**Objet:** Flash info Technique : Nouvelle carte 4 voies LON FTT Directe - CE00446  
**Importance:** Haute

# Flash Info Technique

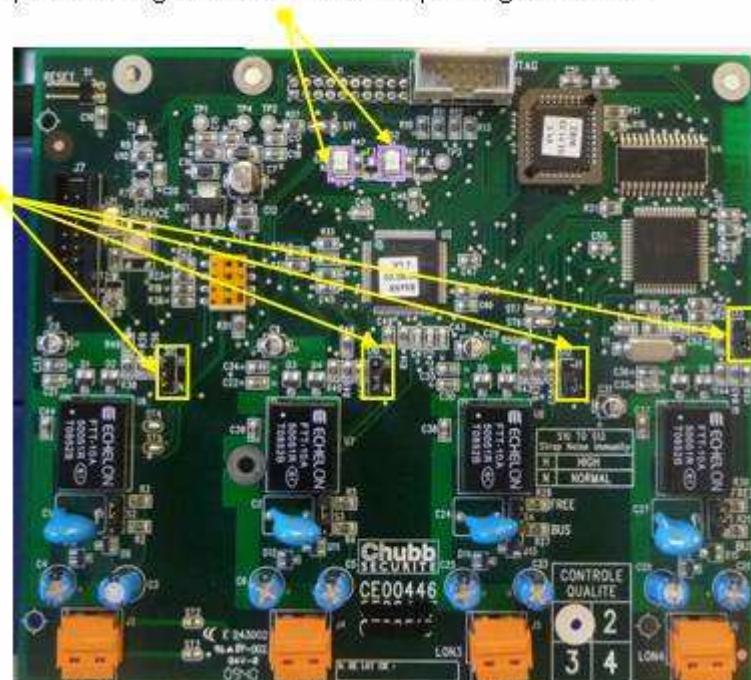
La carte 4 voies LON FTT directe - CE00446 - a évoluée et est passée en révision 0005.  
 Elle reste optionnelle dans les UTI.Com, UTI.Pack, UTC.Com et est de base dans le CMSI.Com.  
 Elle permet le raccordement des cartes LON FTT (UAI LON FTT, UCR, SAT-I, LONREP etc ...)

Ces deux LED peuvent clignoter mais ne sont pas significatives.

### Position des cavaliers S10, S11, S12, S13:

- H (High – haut) : Non utilisée
- N (Normal) : position par défaut
